Maryland Zoo in Baltimore Chesapeake Flyway
Responses to Bidder Questions and Written Identification of Modifications to Project Documents

BULLETIN NO. 1

TO: BKP
ATTN: Crystal Collado
PROJECT: Chesapeake Flyway
PROJECT NO : 11045
CHANGE BULLETIN NO. : CB-1 DATE: October 1, 2026
COORDINATE WITH CB NO. : None PREPARED BY: Stephen Jones
Bobby Biddinger

DRAWING NO:
M102

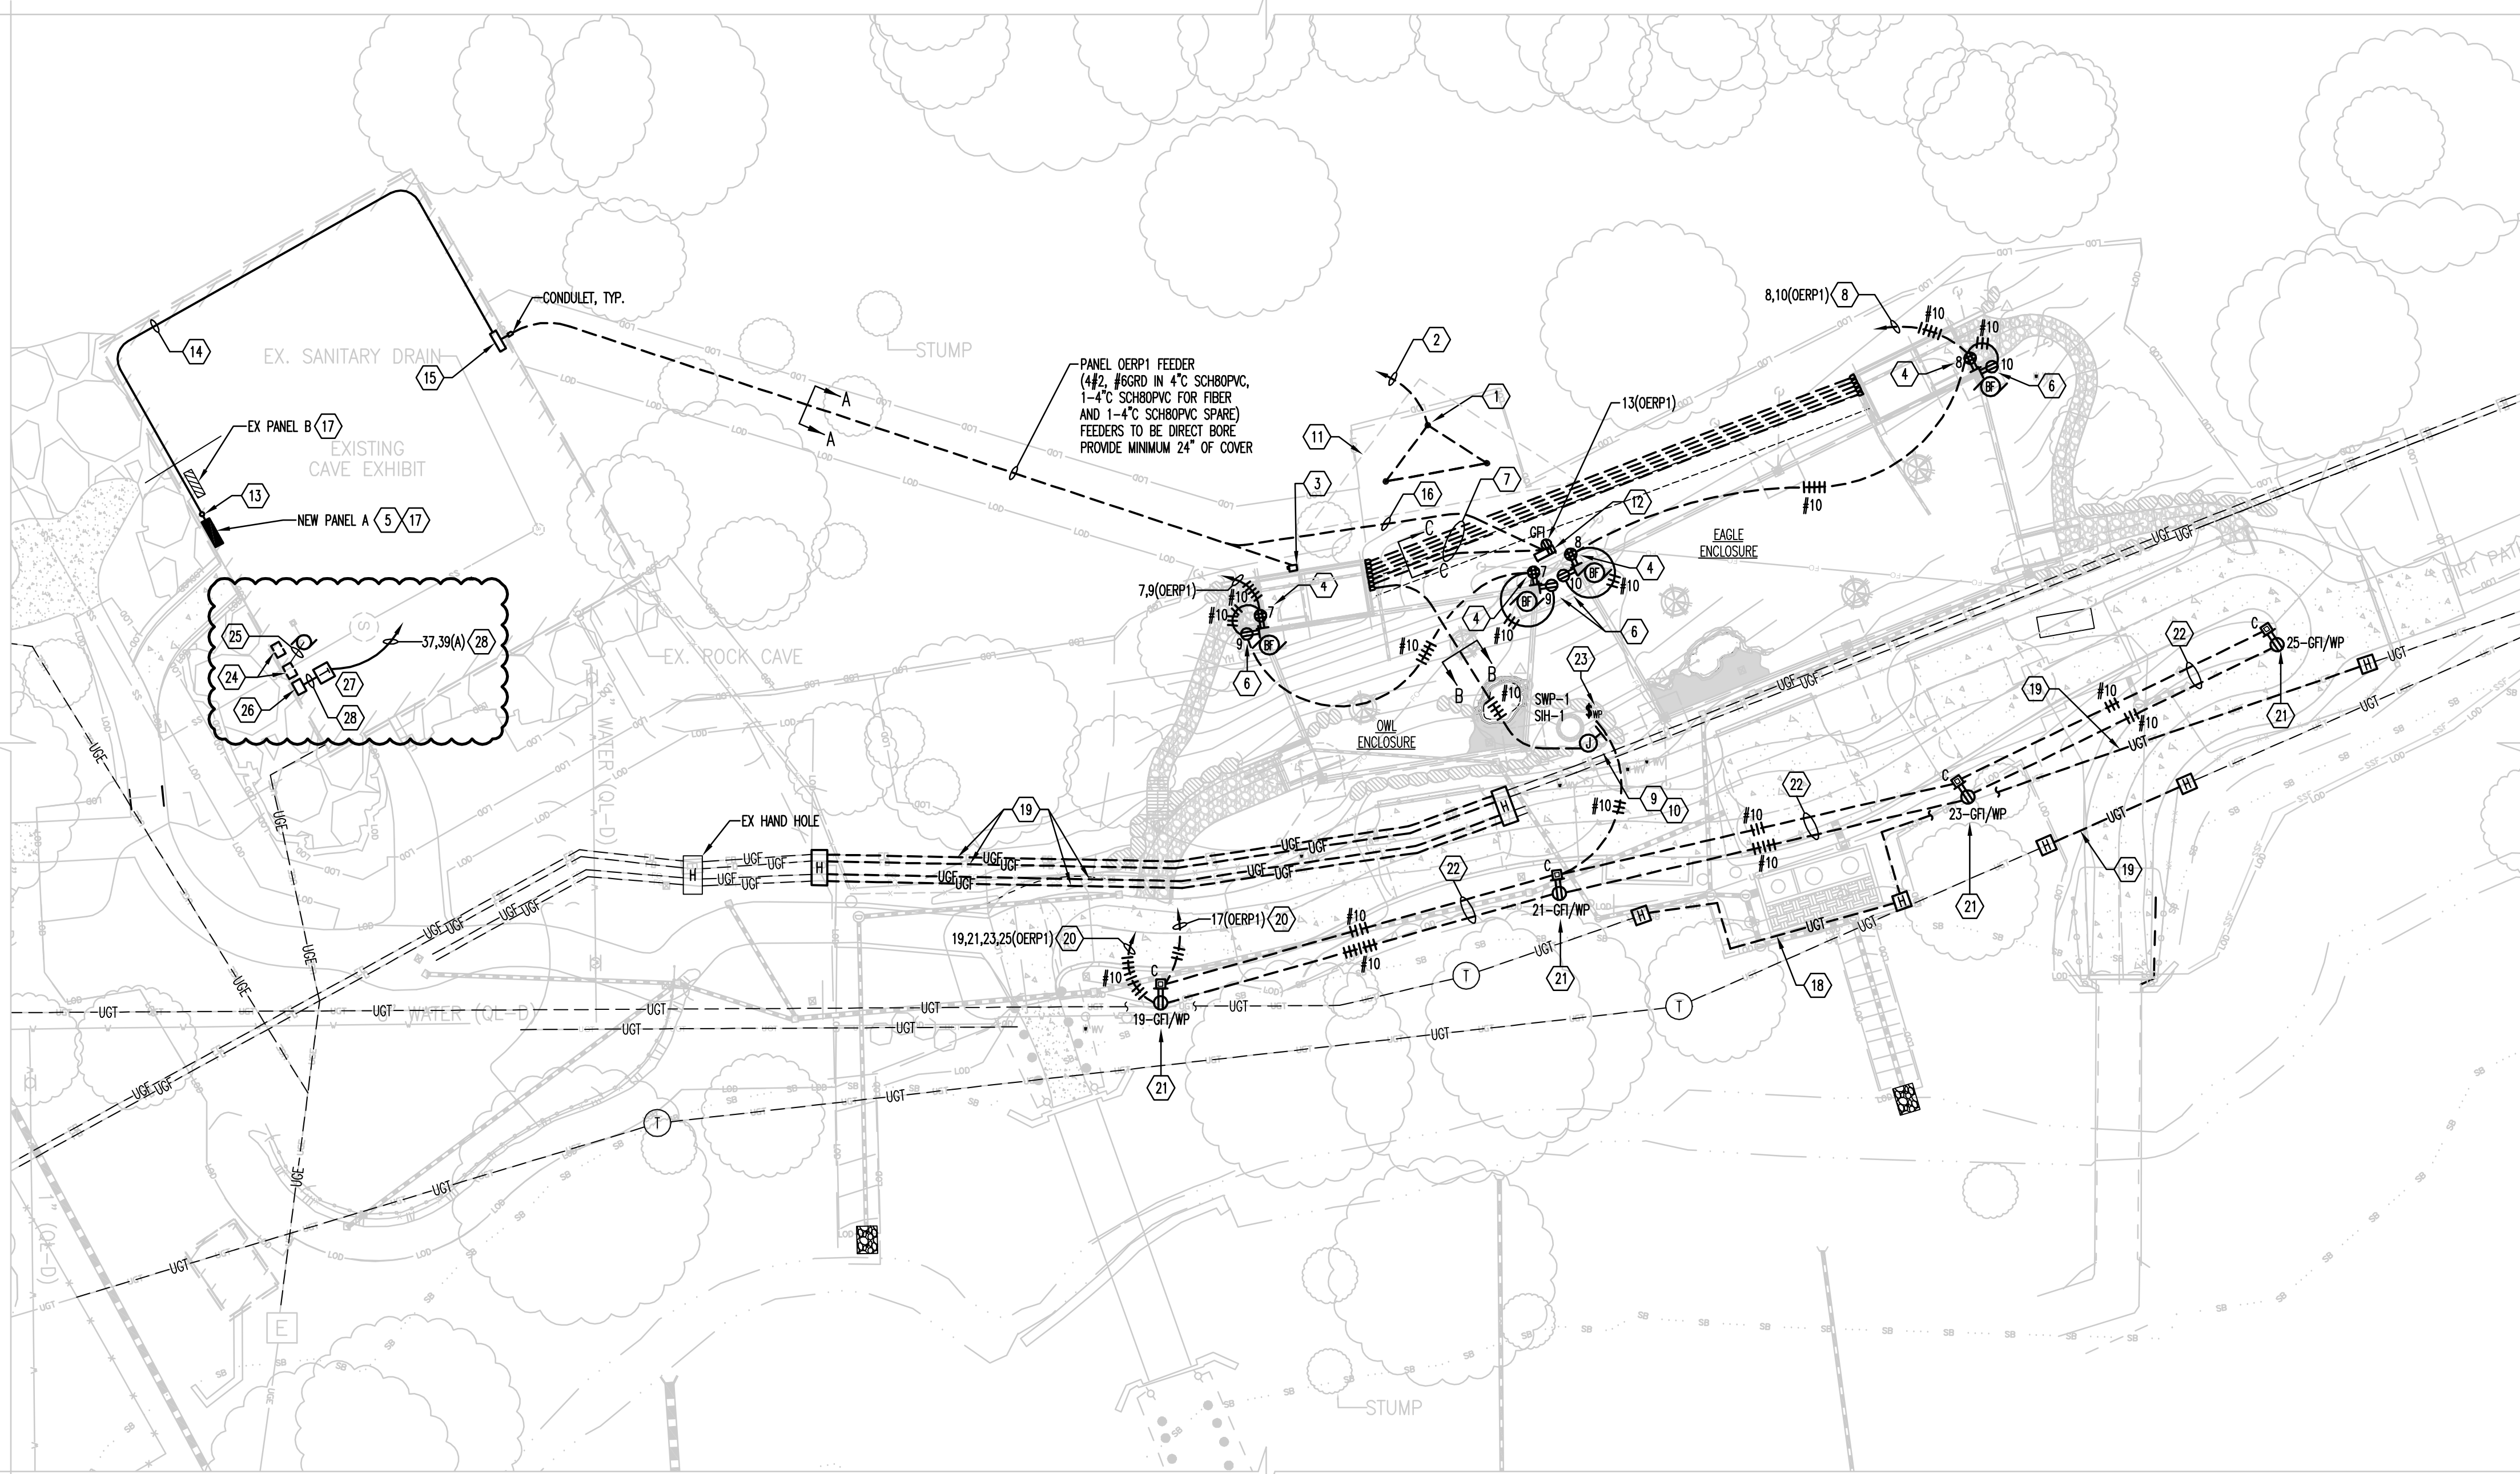
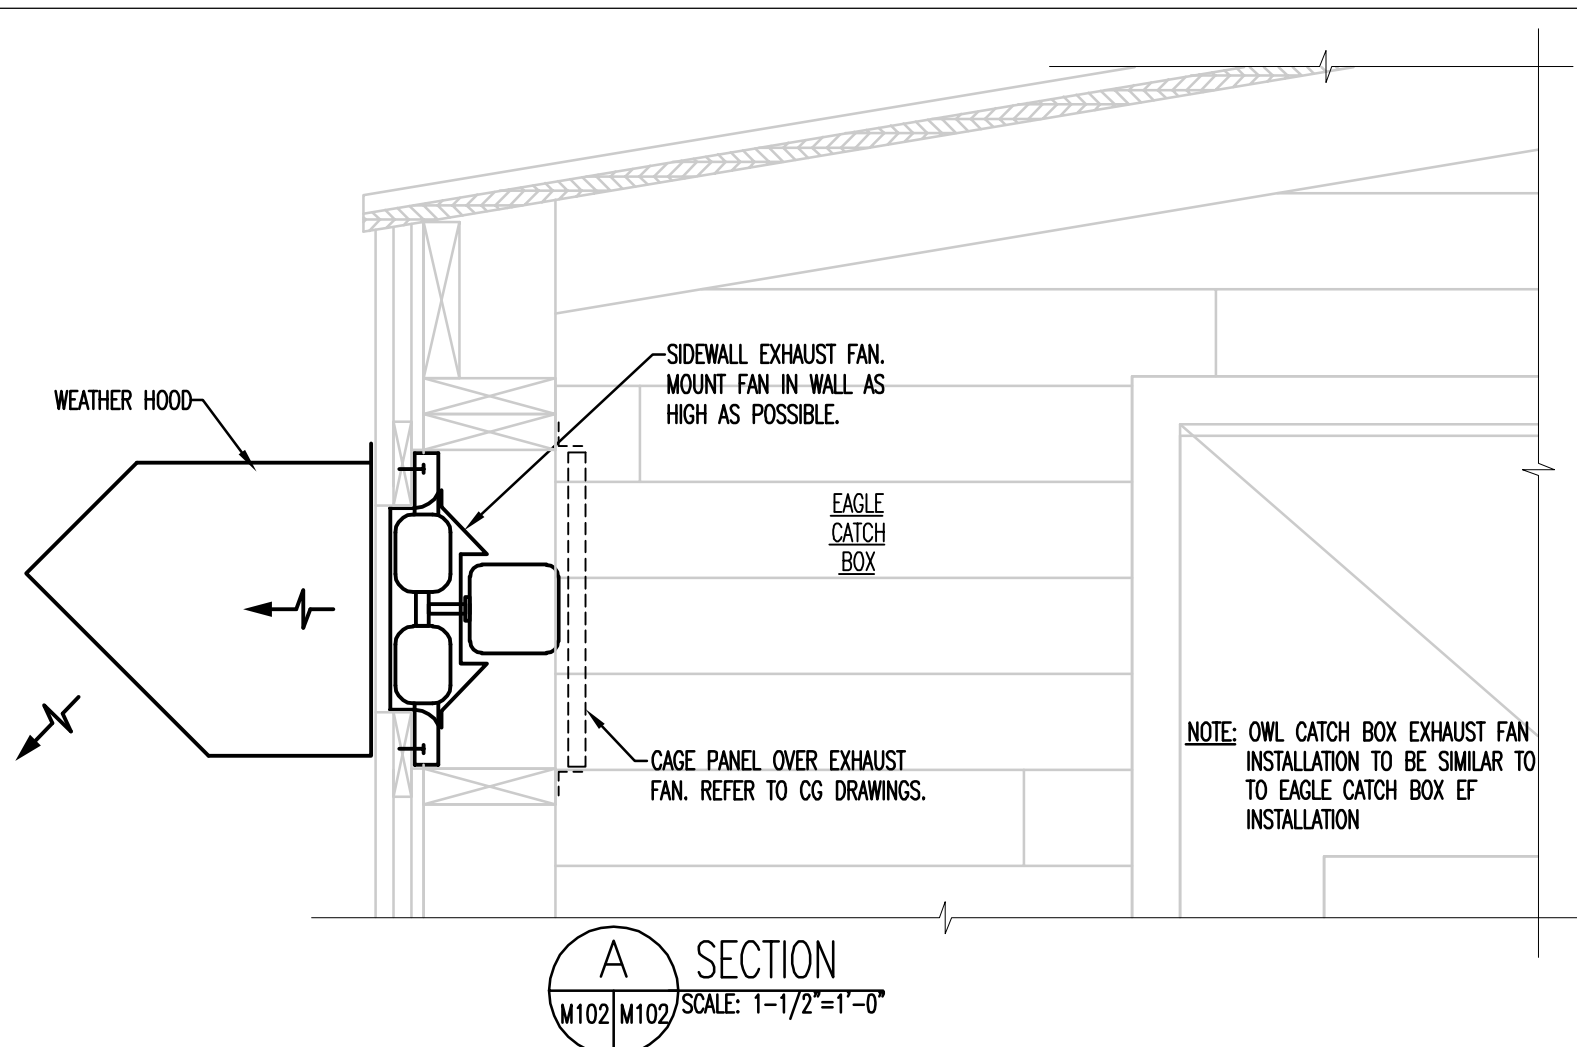
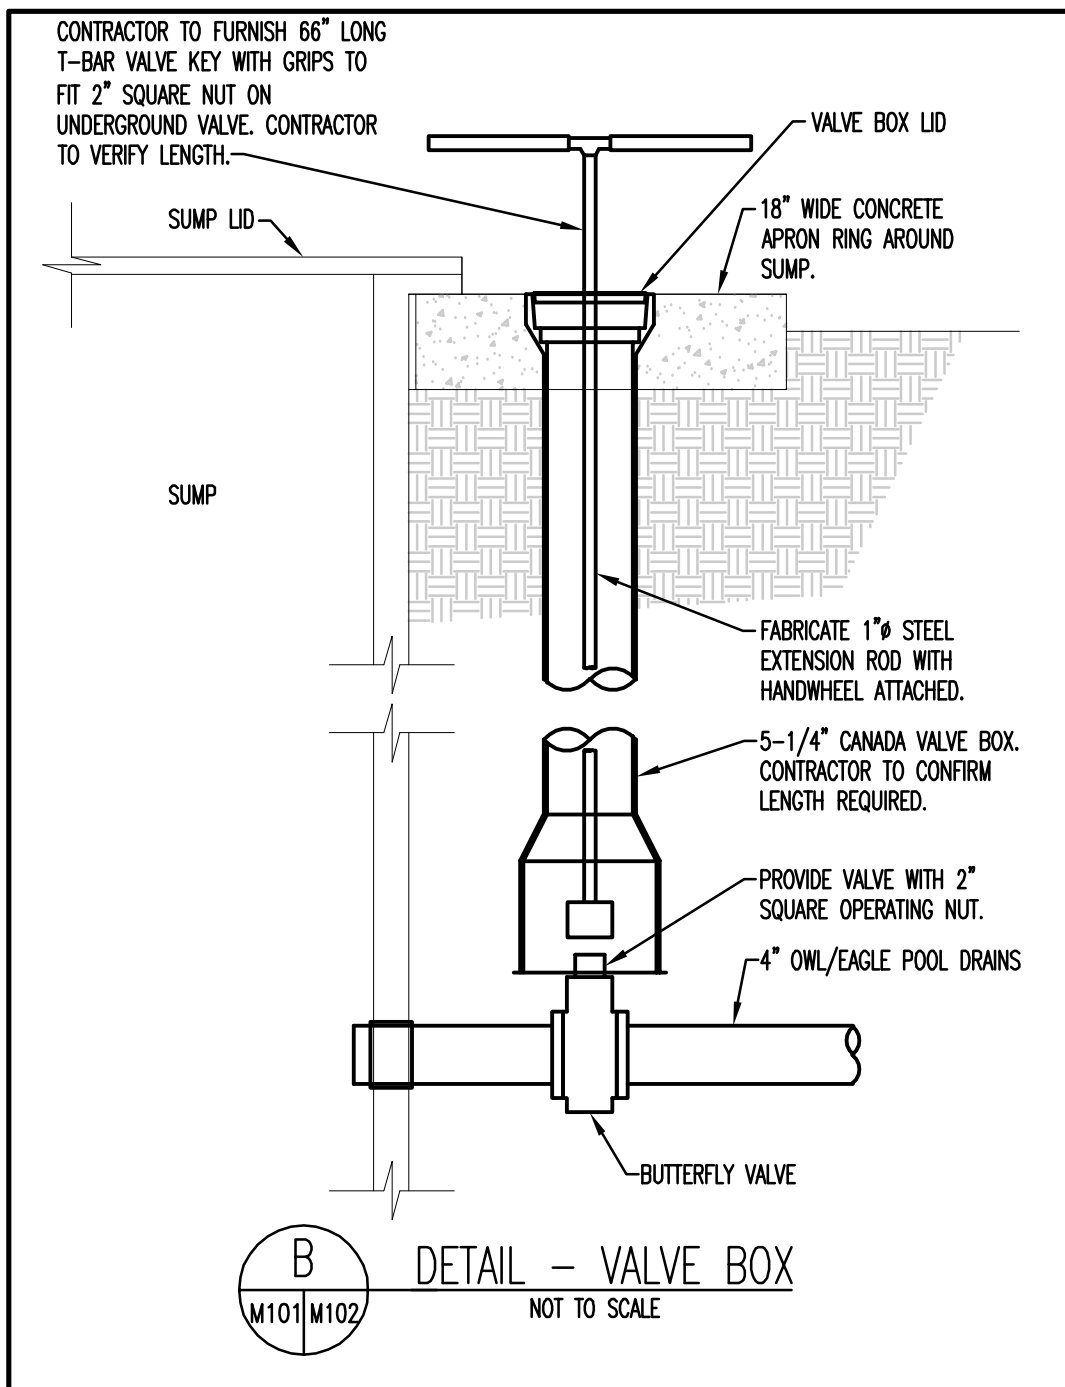
2. Specification Section 220523 paragraph 2.3 calls for a pool drain butterfly valve, but detail C on dwg M102 shows a ball valve. Please confirm that a butterfly valve should be used in this location.

16. Scope clarifies Yard Hydrants are provided by others. Is 23A responsible for Vacuum Breakers and Concrete Protective Bases indicated on M102?

17. Detail on M102 indicates an 1/8" drain port. Do Yard Hydrants require dedicated drain line piping?

Response: Refer to Bid Set dated 09/01/2026

Response: Yard hydrants are NOT provided by others and are to be included in scope. Division 22.

Response: No. Drain port drains water underground into surrounding soil.

S303

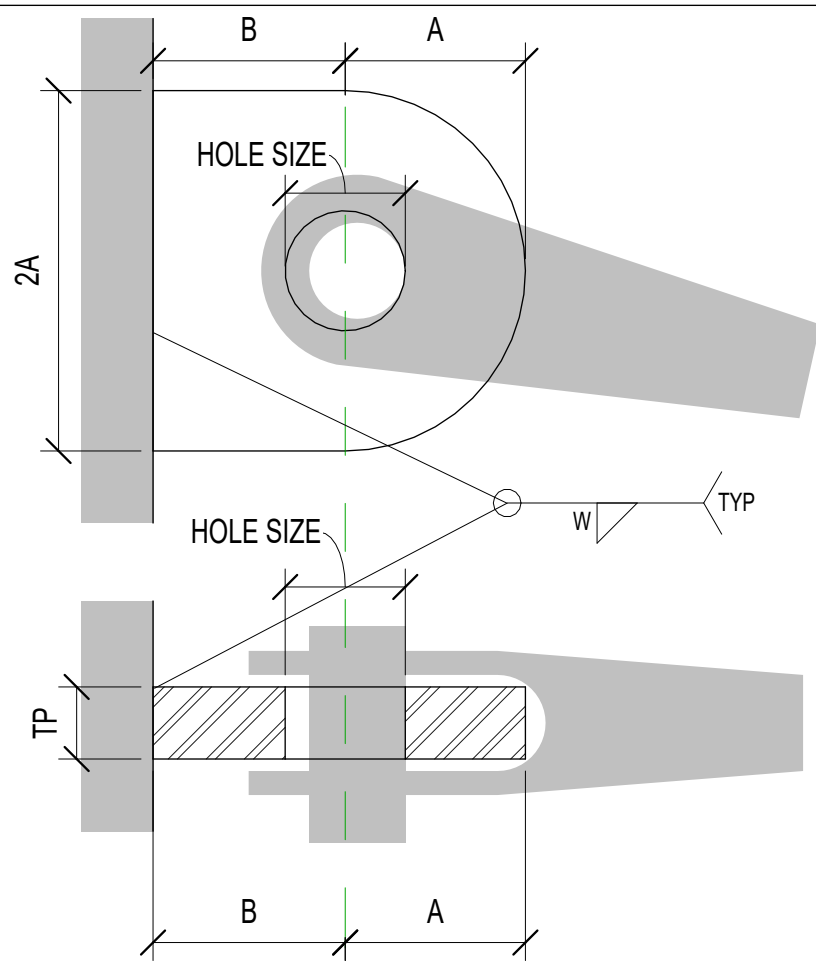
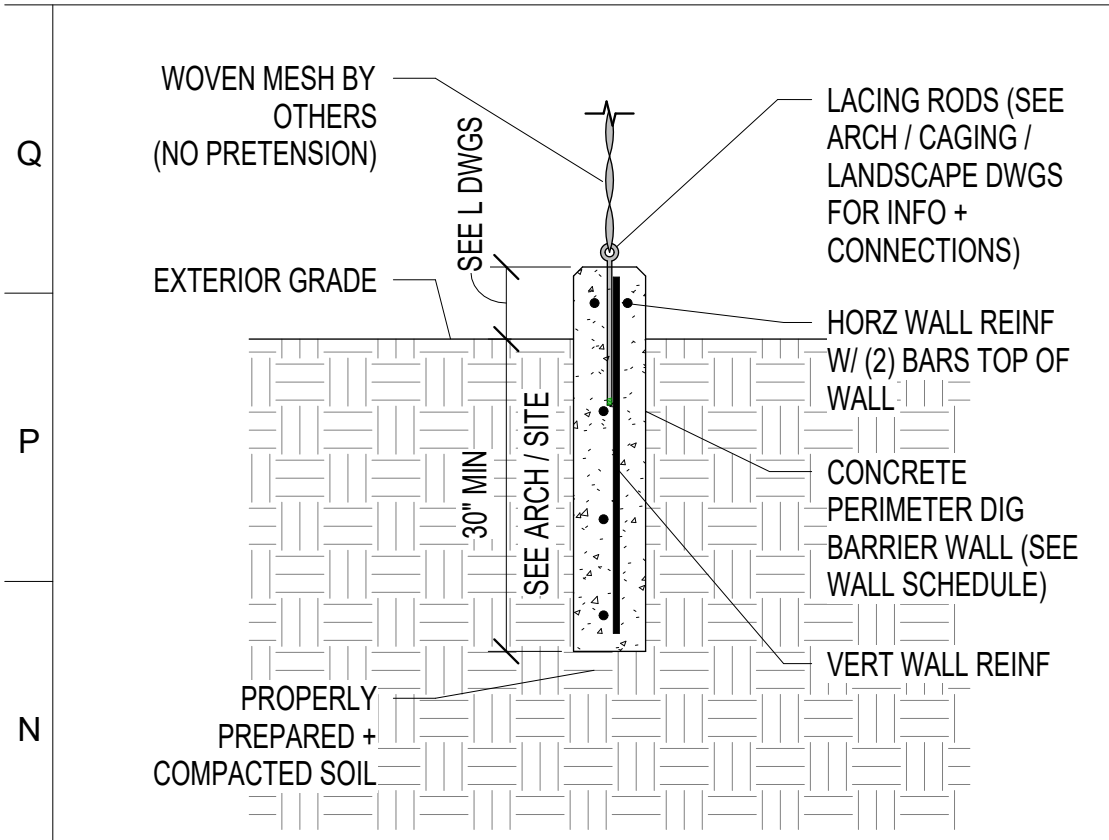
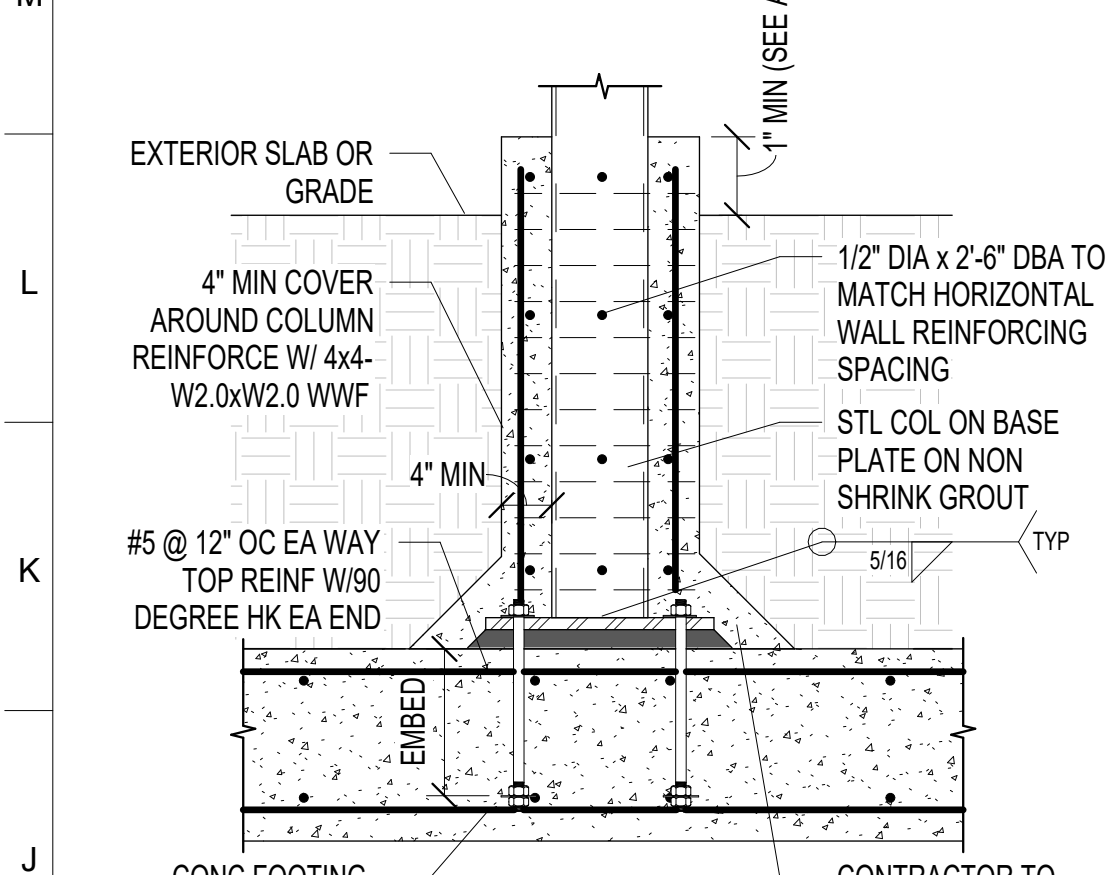
4. The geotechnical plan provided by Century Engineering notes that helical anchors are not appropriate for the site however A1/S303 note 5 states the design intent is to use helical piles in lieu of rock anchors. Please confirm what method should be assumed in the base bid.

Response: See updated S303 note 5 to indicate the use of rock anchors.

A5
S531
Scale: NTS
TYPICAL CATCH BOX BEAM TO COLUMN DETAIL

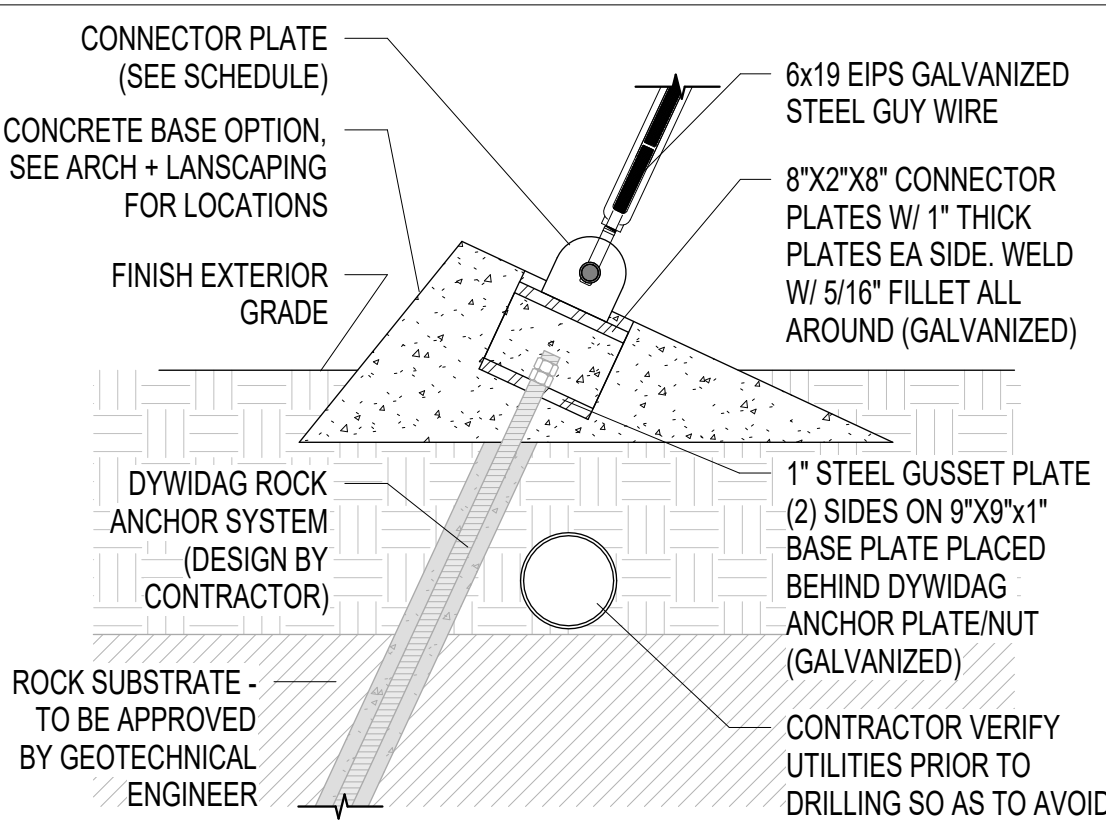
21. Detail H1/A120 indicates steel across the top of the catchboxes for netting attachment however the structural drawings do not indicate how the steel is to be attached. Please provide structural details for this attachment and at the vestibules.

Response: Steel header at catchboxes are 6"x4"x3/8" and vertical post is 4"x4"x3/8". See detail A5/S531 for HSS to HSS welding requirements.
